Work Order ID 133390

Item Name: Quick Release Basket and Long Cargo Tube Mounting Provisions, Fits LH or RH

DART SERVICE INSTRUCTION

TO AMEND INSTALLATION INSTRUCTIONS D350-607-3 Rev.D,
INSTALLATION INSTRUCTIONS D350-607-4 Rev. C AND
INSTRUCTIONS FOR CONTINUED AIRWORTHINESS ICA-D350-607 REV. 6
REF TCCA STC: SH94-14
REF FAA STC: SR00213NY
REF EASA STC: EASA.10016996
REF BRAZILIAN STC: 2007S03-03/-04/-05/-06

FIGURE 1: INSTALLATION OF D4775-041 FWD STRUT

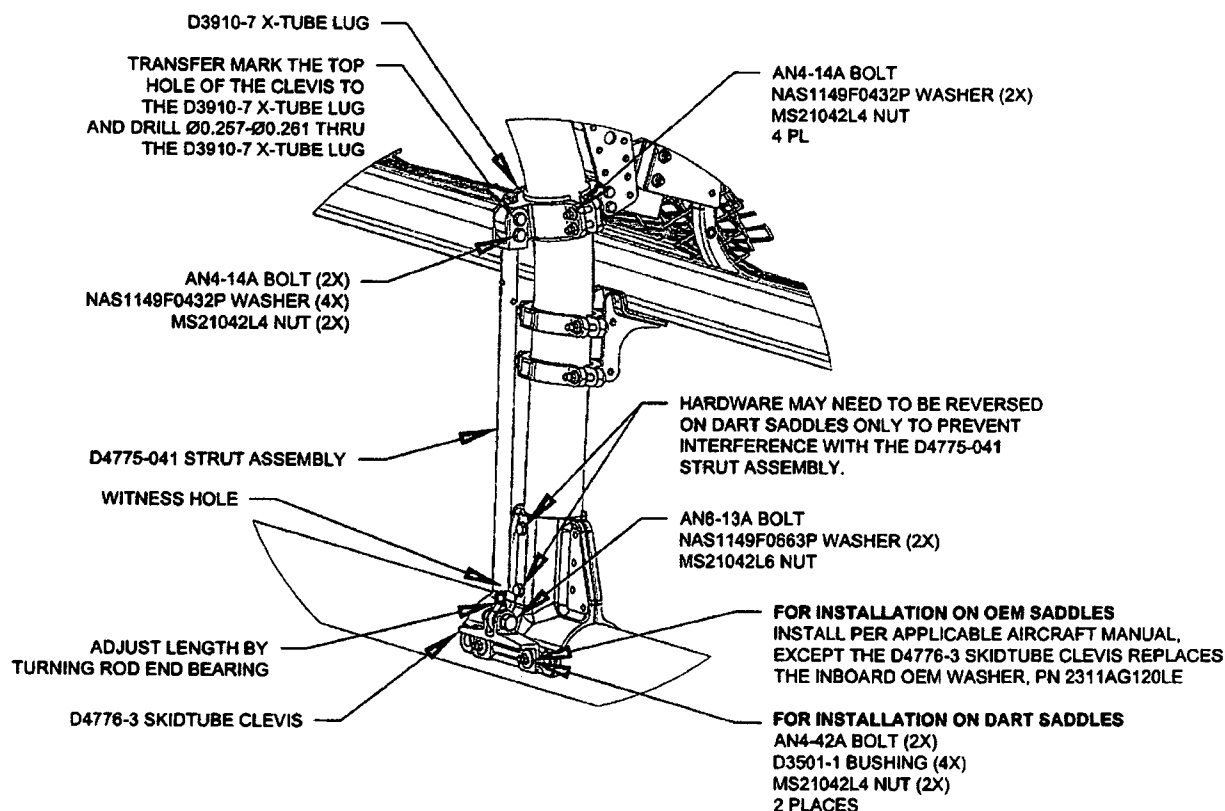
- 3.1 Substitute the Forward Lower D3910-5 X-Tube Lug with the D3910-7 X-Tube Lug as shown in Figure 1.
- 3.2 Install the forward D4775-041 Strut Assembly. Transfer mark from the upper hole on the clevis of the D4775-041 Strut Assembly to the D3910-7 X-tube Lug and drill thru the lug $\varnothing 0.257$ - $\varnothing 0.261$ as shown in Figure 1. Touch up chemical conversion coating per MIL-DTL-5541. Check the witness holes located at the bottom end of the D4775-041 Strut Assemblies to ensure that the thread from the rod end extends past the witness hole.
Torque MS21042L4/-4 nuts to 50-70 in-lbs (5.7-7.9 N-m). Torque MS21042L6/-6 nuts to 160-190 in-lbs (18.1-21.5 N-m).
- 3.3 Complete the installation in accordance with Installation Instructions D350-607-3 Rev. D or D350-607-4 Rev. C.
